OFFICE OF PLANNING

CASE NO. 08-25
EXHIBIT NO. 24

TO: District of Columbia Zoning Commission
FROM: Jennifer Steingasser, Deputy Director *JS*
DATE: February 23, 2009
SUBJECT: Public Hearing Report for Matthews Memorial Church - ZC #08-25
Consolidated Planned Unit Development and Related Map Amendment

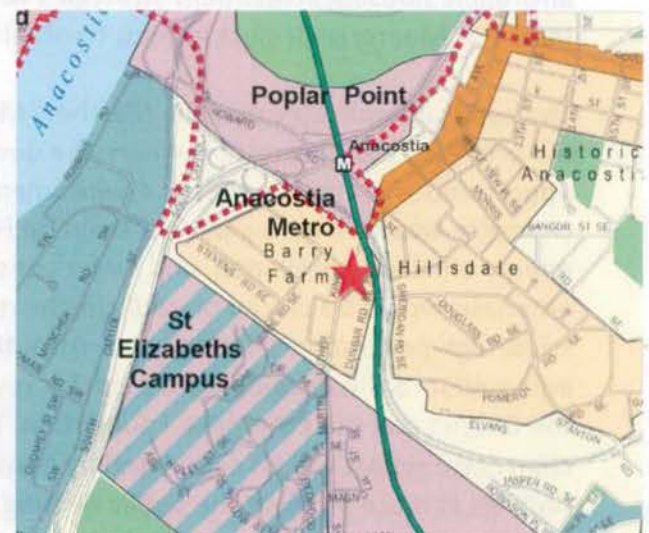
A traffic impact study was performed by Symmetra Design. The study included an assessment of existing and future traffic conditions for am and pm. The analyses included traffic associated with the Matthews Memorial project plus other planned projects in the area was used to generate traffic associated with the proposed development. The study area included the following intersections:

- MLK Avenue/ Howard / Sheridan Roads
- MLK Avenue/ Stanton / Sumner Roads
- MLK Avenue/ Unified Communication Center (UCC)/ St Elizabeths West Campus

Since the project will be located approximately 0.3 miles from the Anacostia Metro Station on the Green Line, 40 percent transit reduction was applied to residential vehicular trips and 20 percent to office building vehicular trips. The study concluded that the project would not create adverse impacts with respect to traffic and transportation and all of the study area intersections will continue to operate at acceptable levels of service with the addition of the proposed Matthews Memorial project.
